**AGENDA
HISTORIC DISTRICT COUNCIL
REGULAR MEETING
OCTOBER 20, 2022
5:00 PM
CITY HALL COMMISSION CHAMBERS
204 ASH STREET
FERNANDINA BEACH, FL 32034**

- 4. PRESENTATIONS**
 - 4.1 MATERIAL INTEGRITY: WHY HISTORIC FABRIC MATTERS - Salvatore Cumella
- 5. OLD BUSINESS**
 - 5.1 **HDC2022-0063 - POYNTER FAMILY HOLDINGS LLC, 116 N. 2ND STREET**
FINAL Certificate of Approval (COA) to construct a multi-purpose pavilion with gardens, and 3 pickleball courts. (*Quasi-Judicial*)

**MINUTES
HISTORIC DISTRICT COUNCIL
REGULAR MEETING
SEPTEMBER 15, 2022
5:00 PM
CITY HALL CHAMBERS**

SL-2

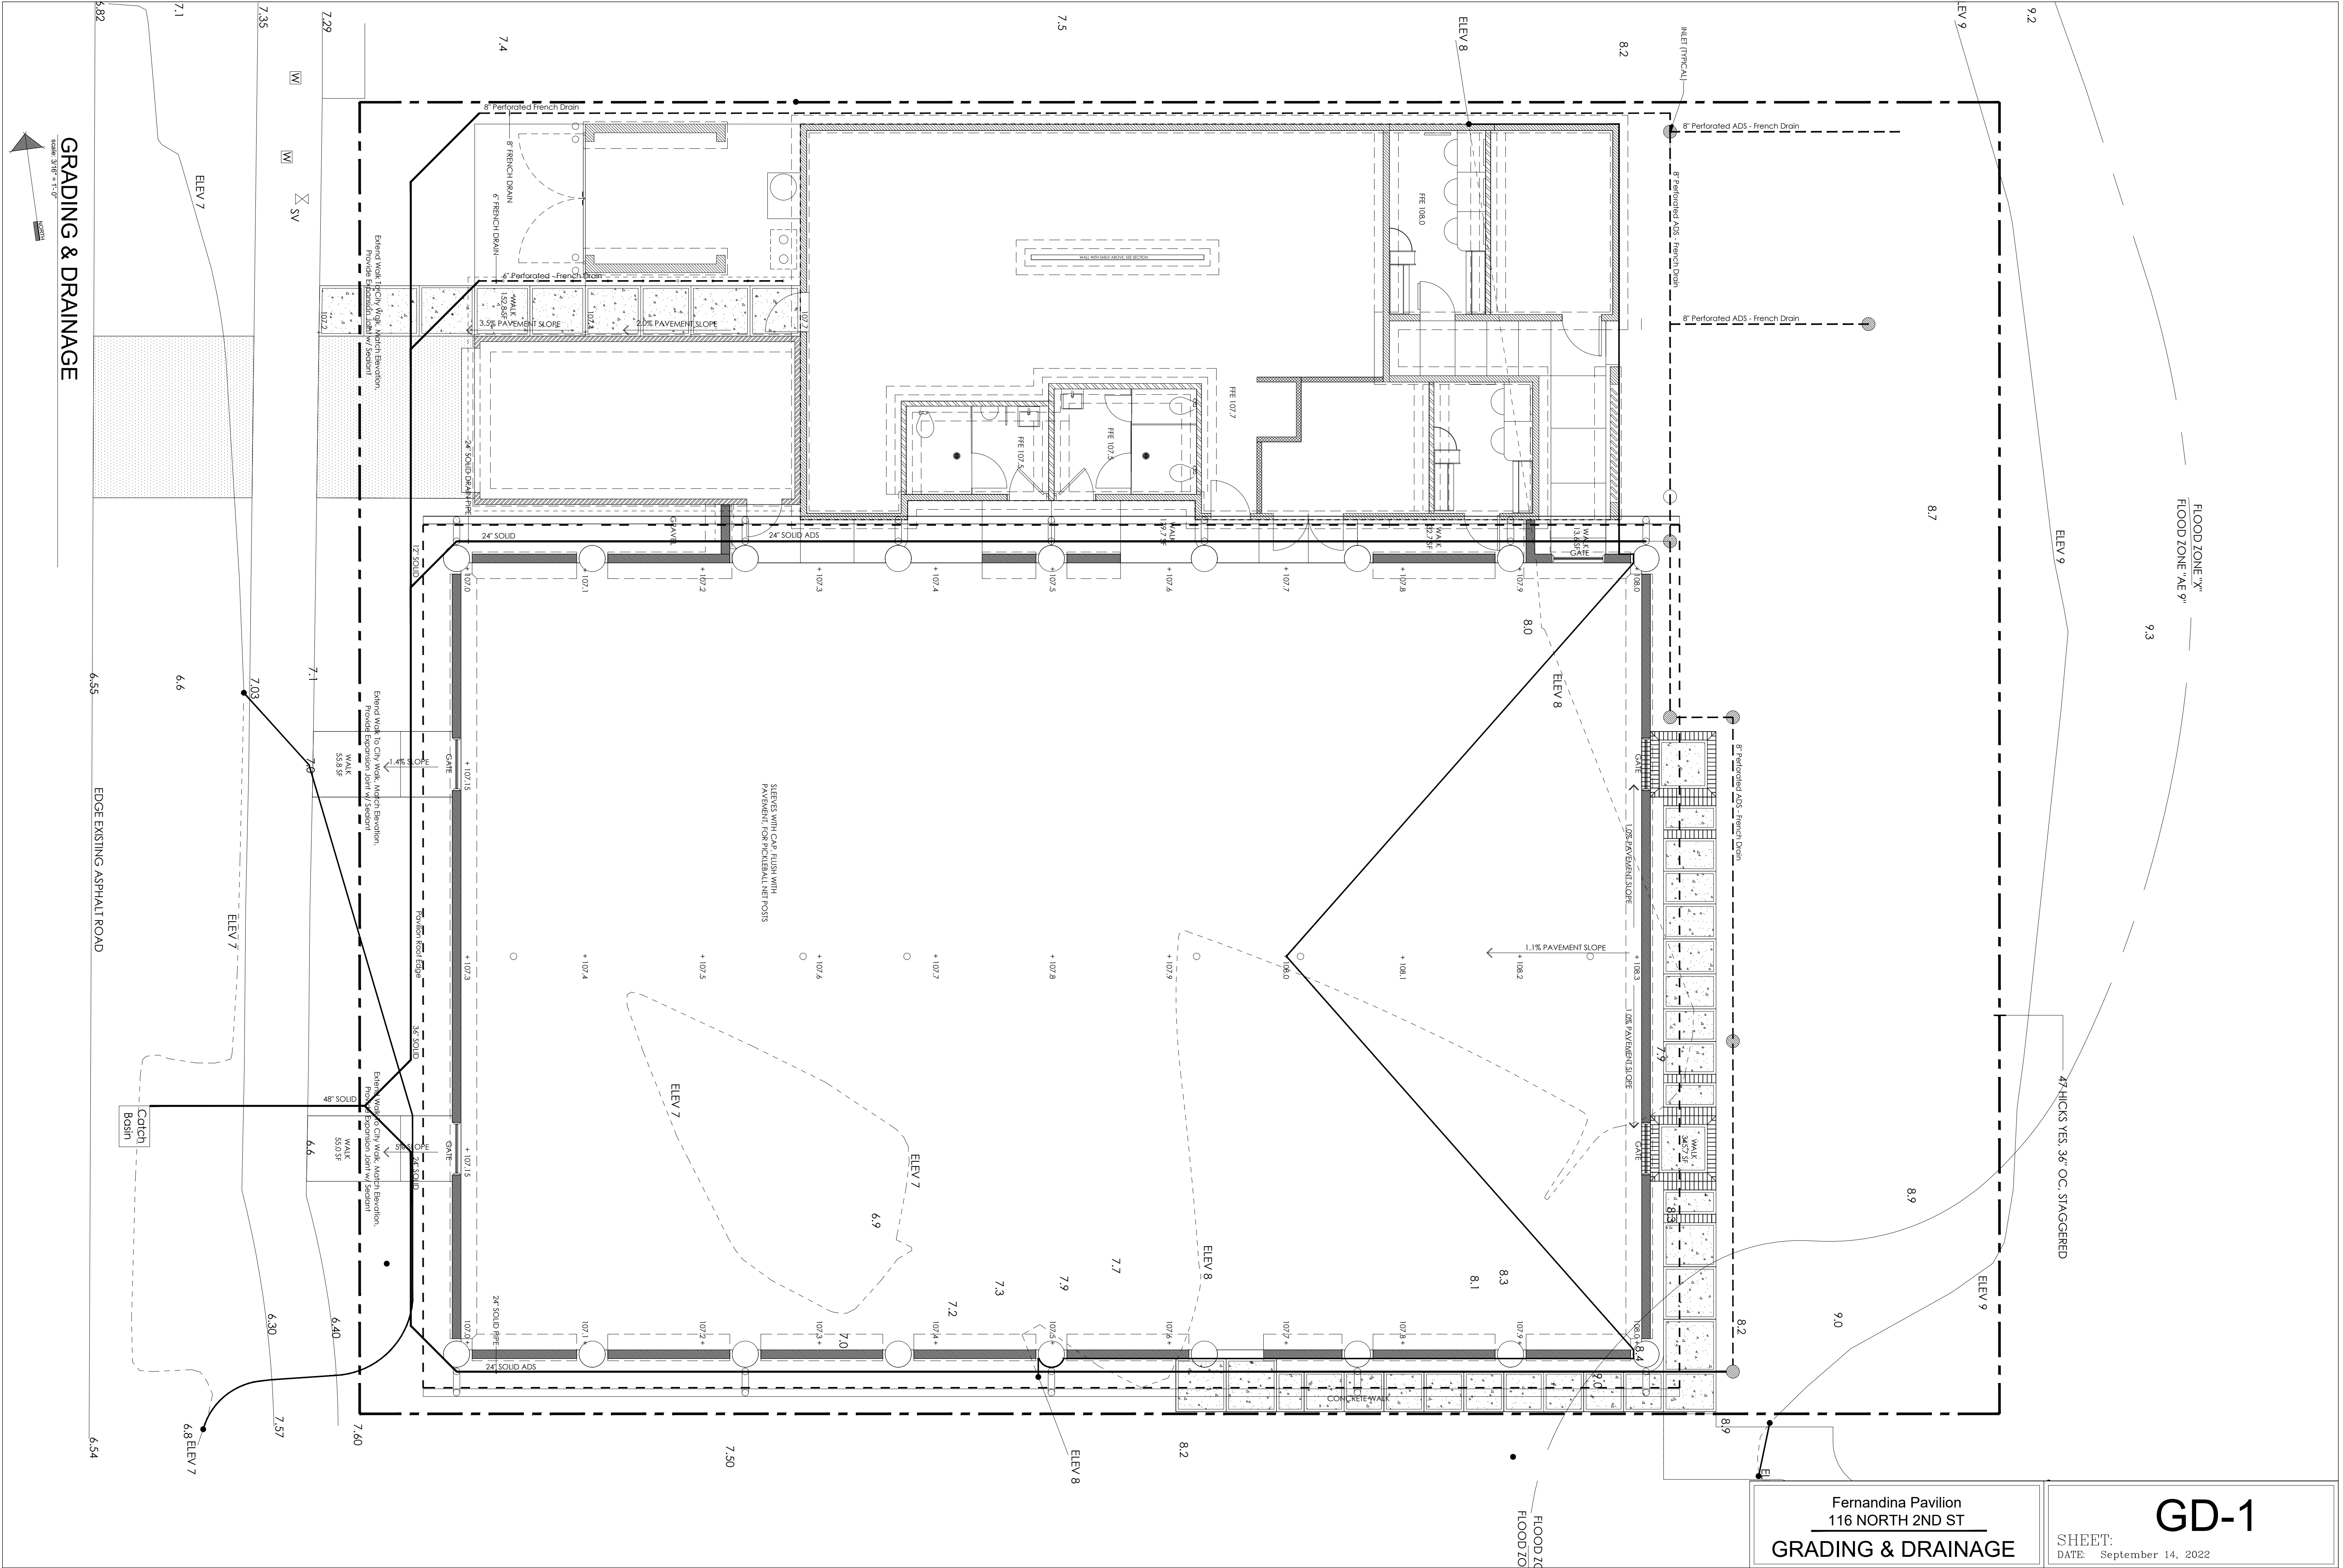
6. Driveway to be reduced to the maximum 25' in width per LDC 7.01.01(E)b.
Single driveway to garage area being shown is 12'4 ½" on sheet SL-1 of
7. Driveway to be constructed of pervious materials.
Driveway materials no identified.

AR-2

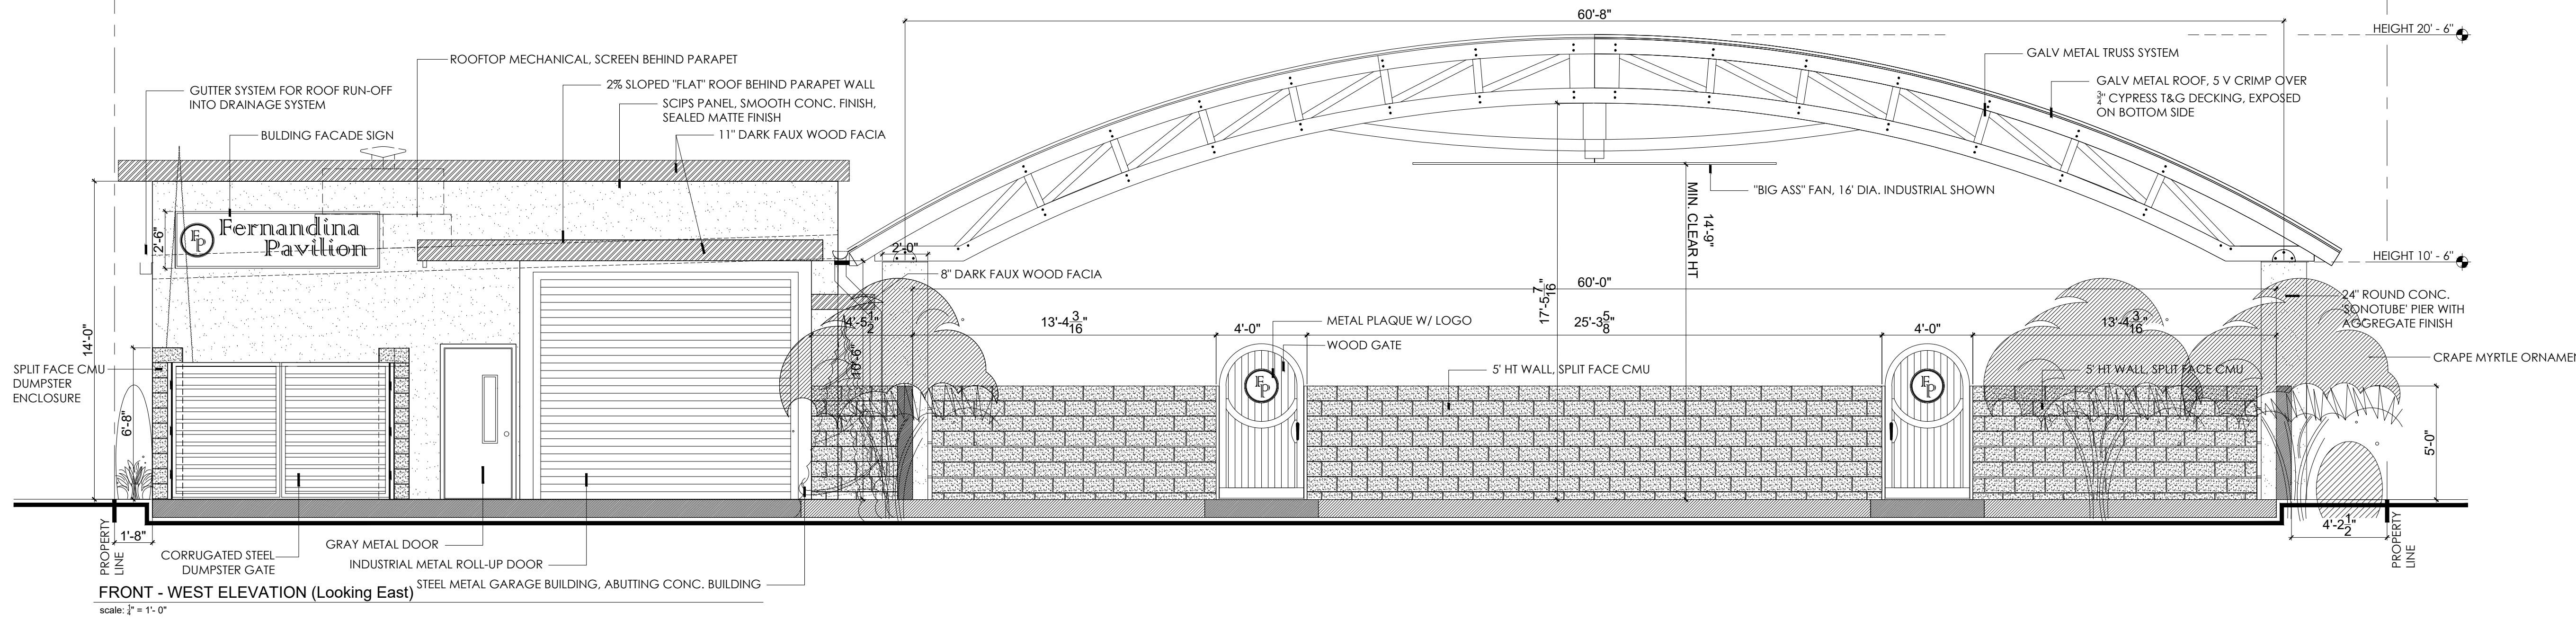
1. All mechanical equipment must be shown on site plan. All rooftop mechanical equipment must be screened from view to adjacent properties and rights-of-way by utilizing parapets or other screening elements that are integrated into the overall architecture of the structure and constructed using materials and methods that are consistent with those used on the building per LDC 8.01.01(G).
Rooftop mechanical is shown to be screened by parapet as shown on sheet AR-5 of EXHIBIT 2.
